**DOMINIC
McKENZIE
ARCHITECTS**

Revisions:		Project: 14 New End Square, London NW3	
A: 23.11.2022		Drawing: Proposed Third Floor	
		Scale: 1:50 @ A3	
		Date: February 2022	
		Drawing Ref: 105_T_23_Rev A

Revisions:		Project: 14 New End Square, London NW3
A: 04.10.2022		Drawing: Proposed Section CC
B: 12.10.2022		Scale: 1:50 @ A3
C: 23.11.2022		Date: February 2022
		Drawing Ref: 105_T_47_Rev C

Revisions:		Project: 14 New End Square, London NW3
A: 04.10.2022		Drawing: Detail - Abutment
B: 06.10.2022		Scale: 1:10 @ A3
C: 23.11.2022		Date: September 2022
		Drawing Ref: 105_C_104_Rev C

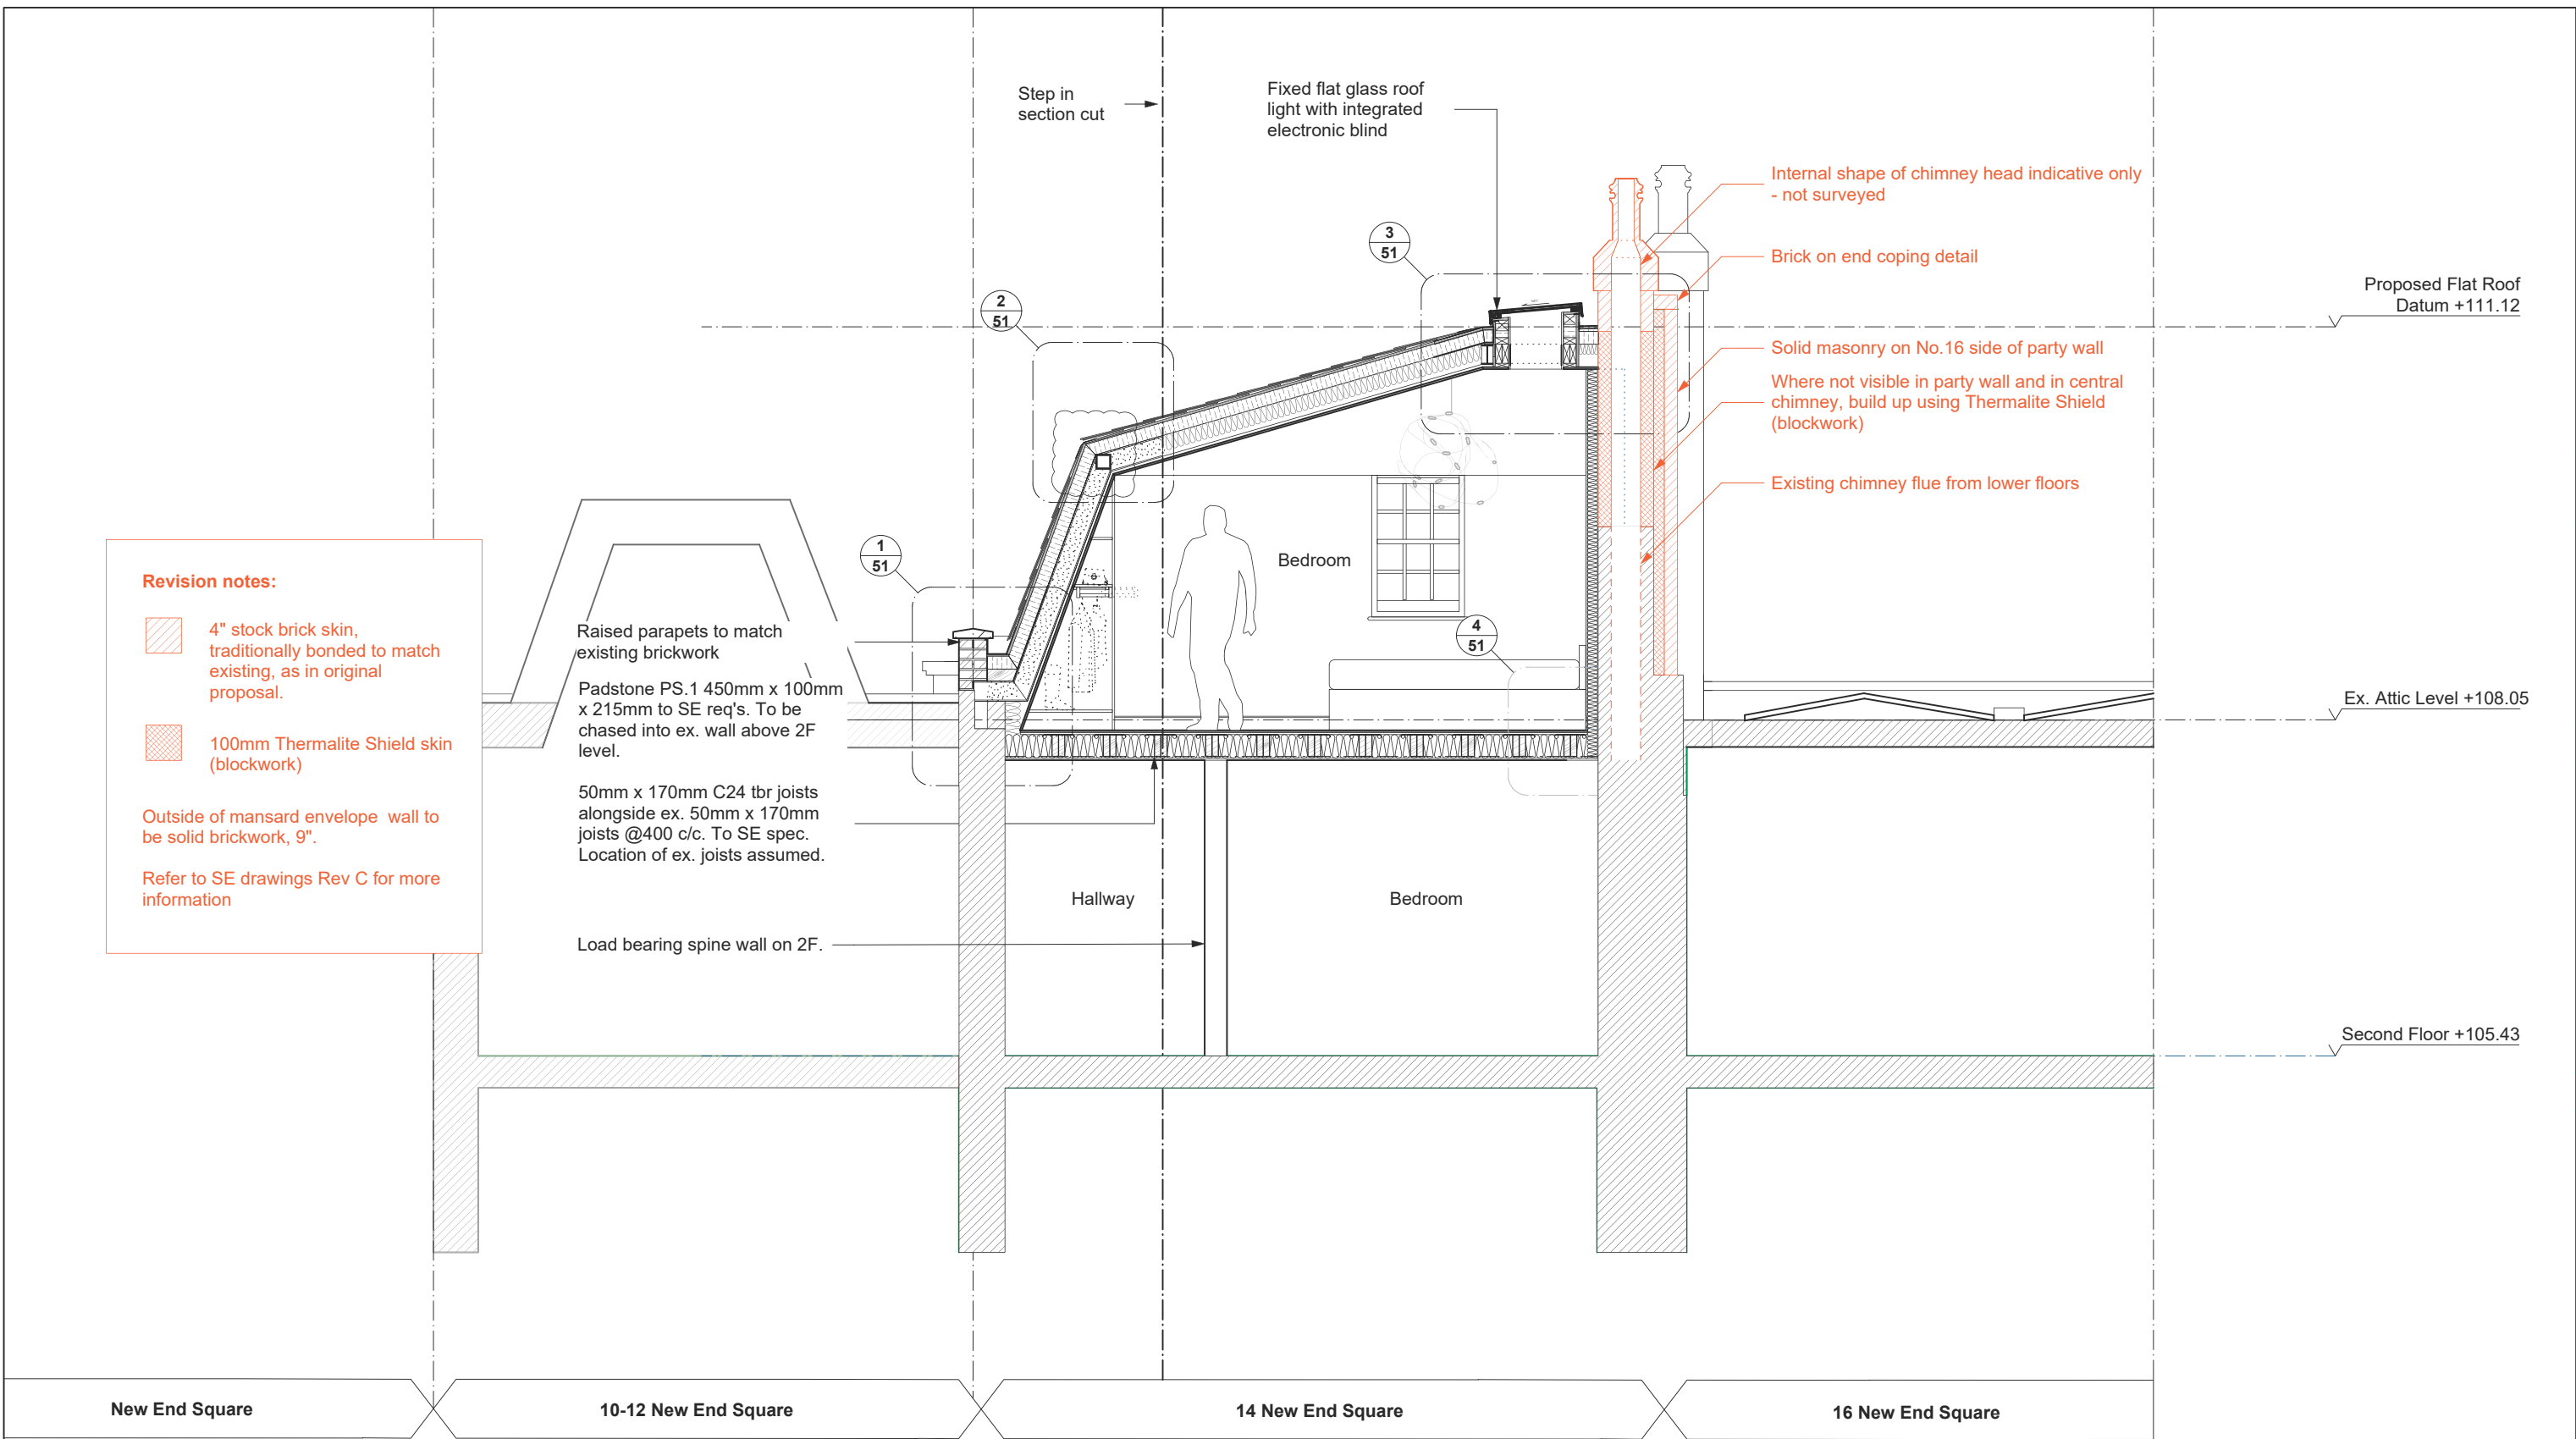
Revision notes:

- 4" stock brick skin, traditionally bonded to match existing, as in original proposal.
- 100mm Thermalite Shield skin (blockwork)

Outside of mansard envelope wall to be solid brickwork, 9".

Refer to SE drawings Rev C for more information

1 PARTY WALL ABUTMENT DETAIL

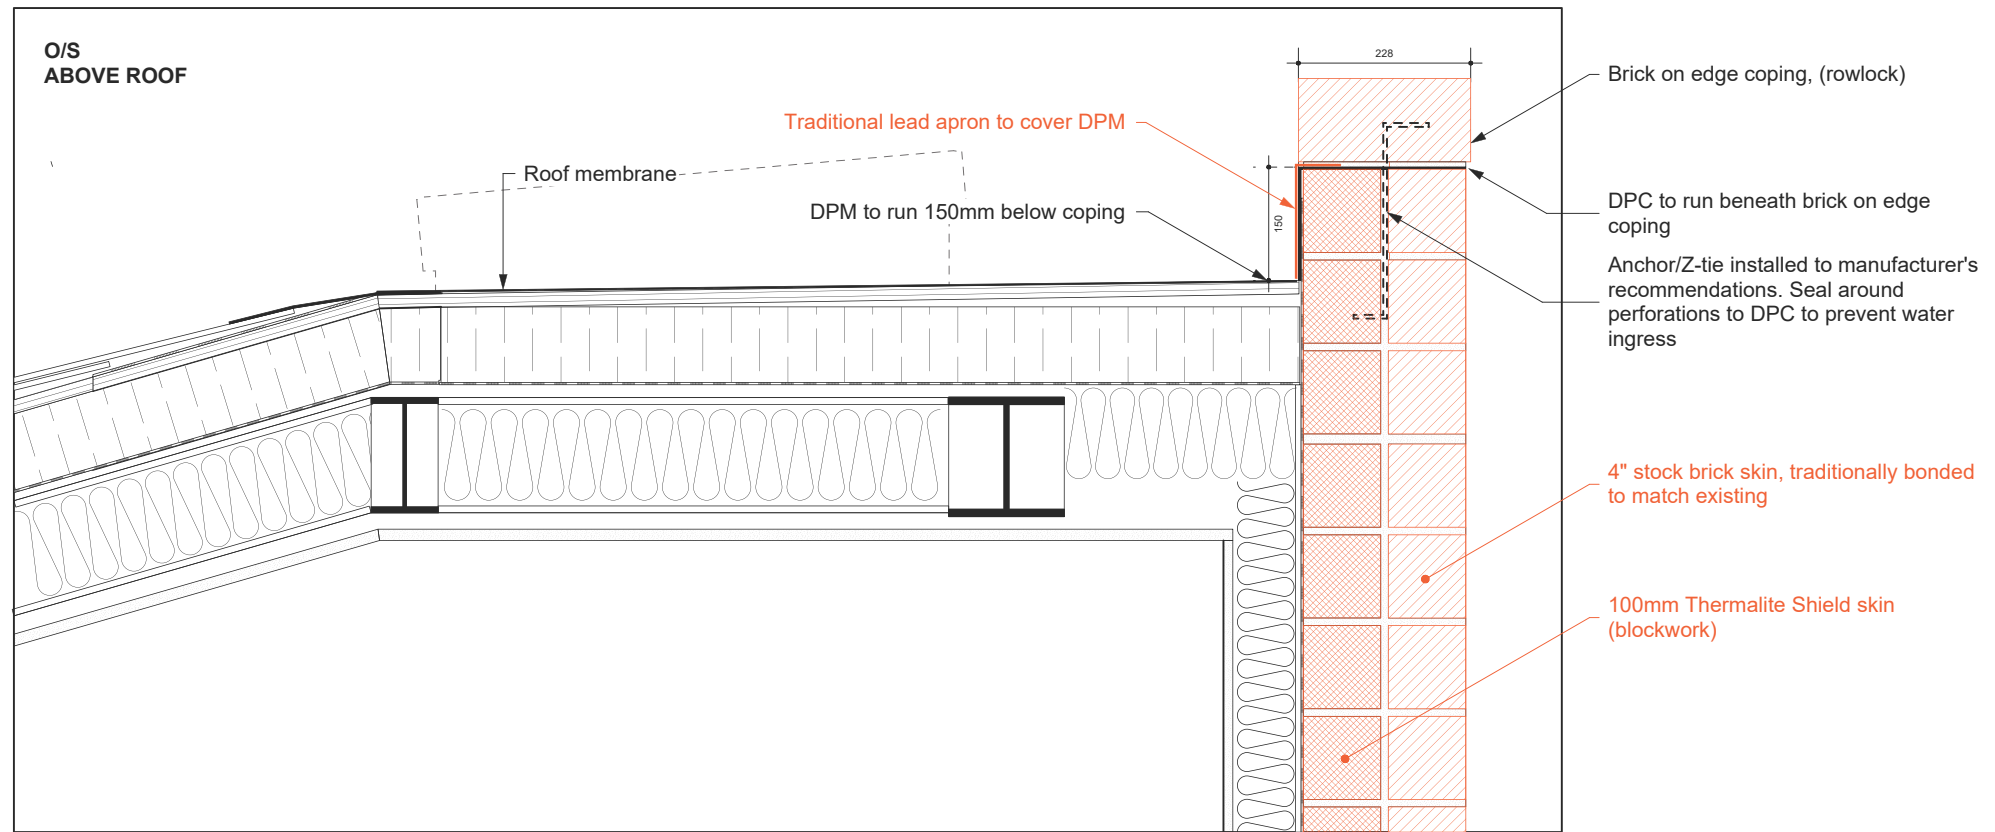
Revision notes:

-  4" stock brick skin, traditionally bonded to match existing, as in original proposal.
-  100mm Thermalite Shield skin (blockwork)

Outside of mansard envelope wall to be solid brickwork, 9".

Refer to SE drawings Rev C for more information
